**WARRANTY
BULLETIN**

WB14-47B

DATE :	OCTOBER 2014	SECTION :	04 - Exhaust
EXPIRATION:	OCTOBER 2016		
SUBJECT :	UREA DOSING SYSTEM UPDATE - X AND H SERIES

REVISION B: THIS WARRANTY BULLETIN SUPERSEDES PREVIOUS VERSION.

Figure 1 US10 / OBD13 Valve cover

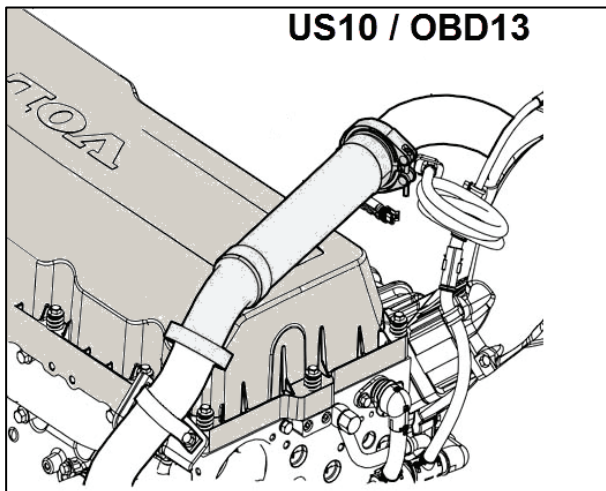
US10 and OBD13 Vehicles

Update according to steps **A** and **B** below.

- A. Connect PTT to the vehicles diagnostic receptacle (DDR or OBD)
- B. Update in the following order: ECM, ACM and VECU (VECU update is required only for GHG14 vehicles)

Figure 2 GHG14 valve cover

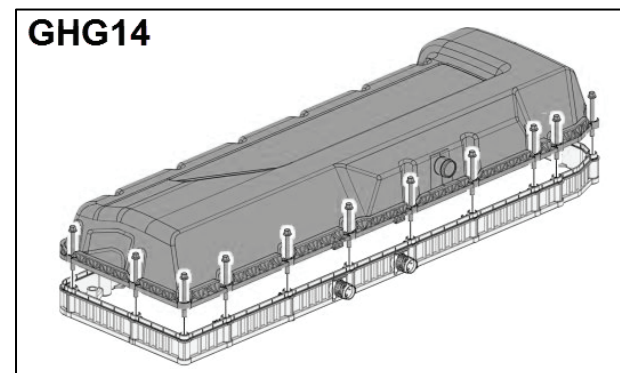
GHG14 Vehicles

Update according to steps **A** et **B** below. And add a VECU update

GHG14 engines have a "split" cover (Fig 2).

Figure 5

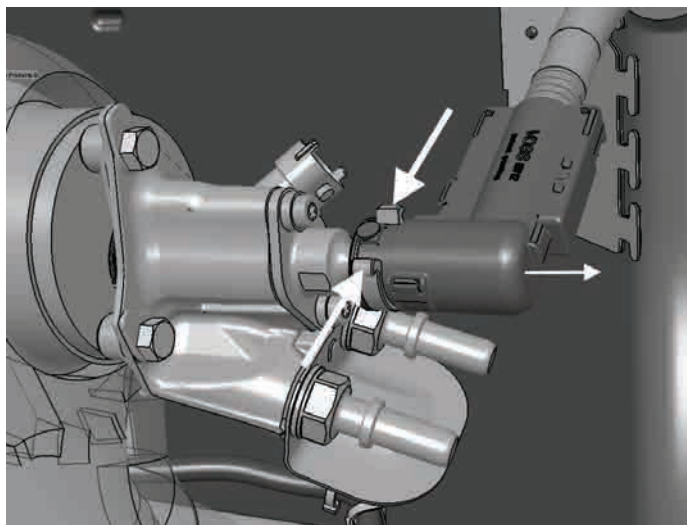
3. Relieve coolant system pressure.
4. Prepare a suitable container to catch any coolant dripping
5. Depress yellow buttons to release quick coupling. (Fig. 5)
6. Mark hose connections to ensure proper reconnection.

Figure 6

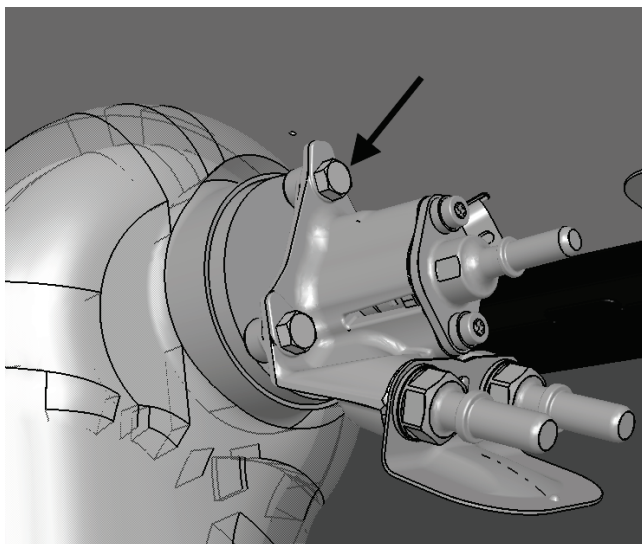
7. Remove electrical connector.
8. *Protect from DEF contamination by taping a plastic bag over the connector.*
9. Disconnect DEF line. (Fig. 6)
